**Correspondence Between
Staff and Applicant
Approval Letter**

Case Reference No: 30-DR-2016 IPA Senior Living Facility

RE: Review Comments
IPA Senior Living Facility
30-DR-2016
Project No. 14-7016-01

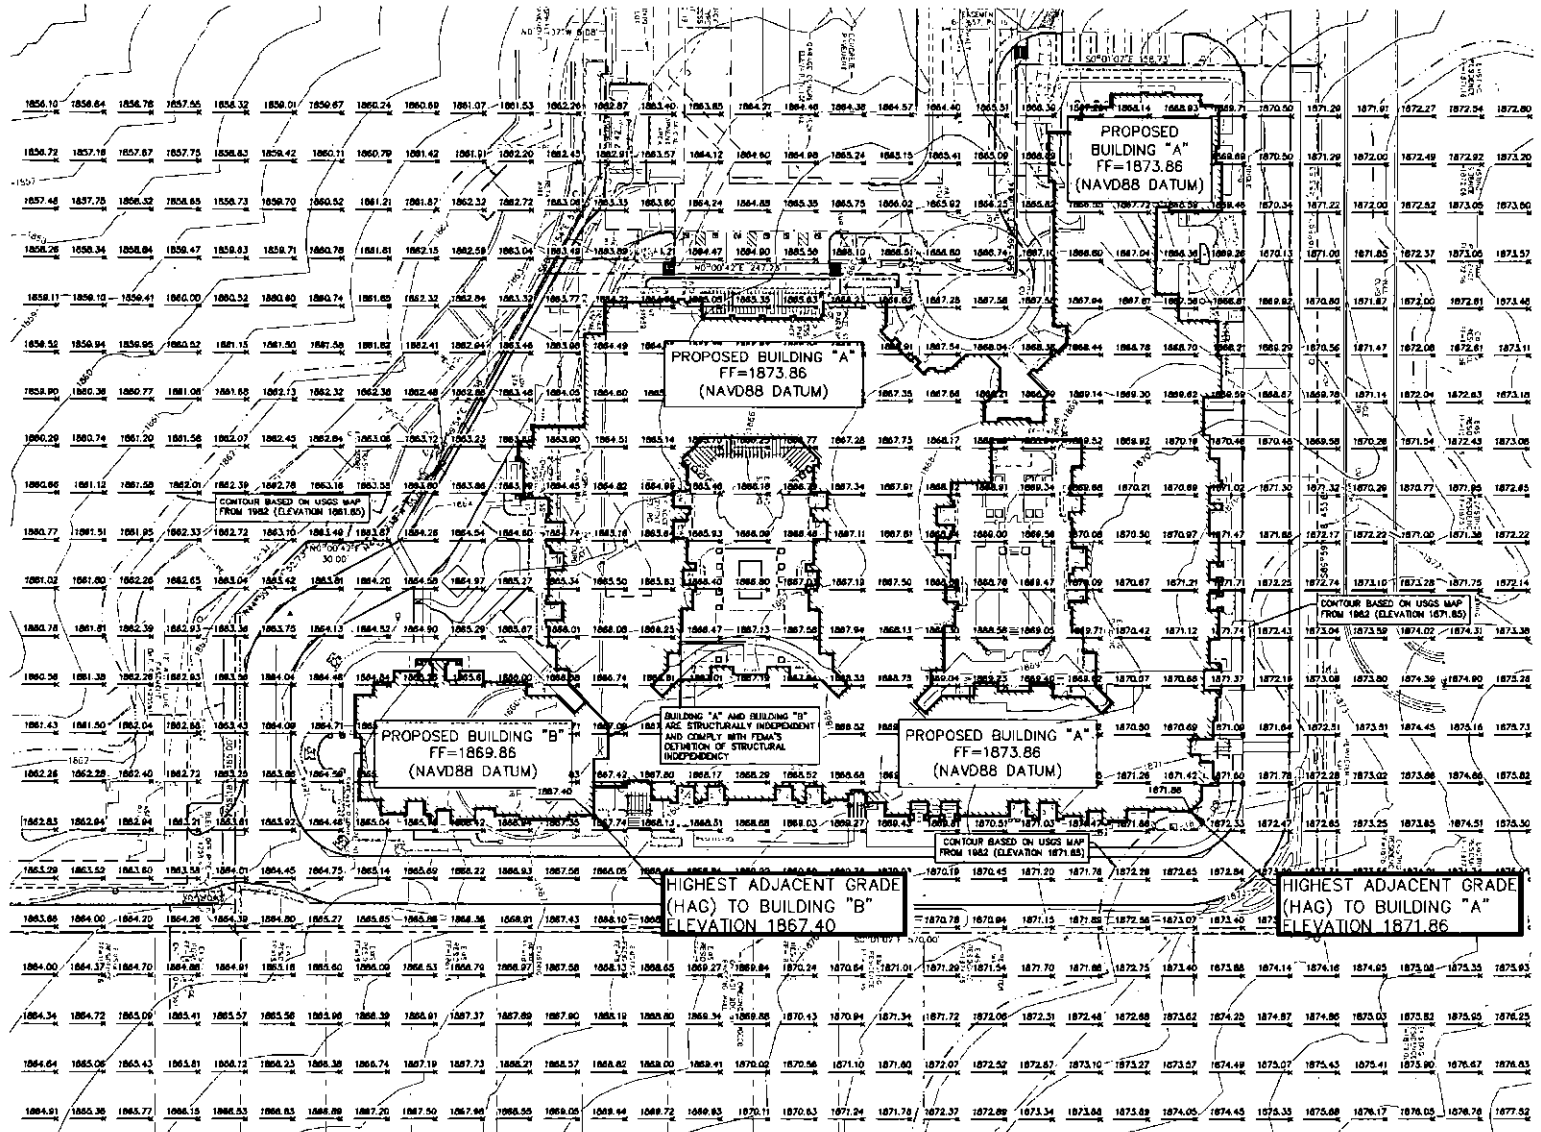
Here is the updated USGS surface exhibit addressing your comments and showing the revised FF elevation.
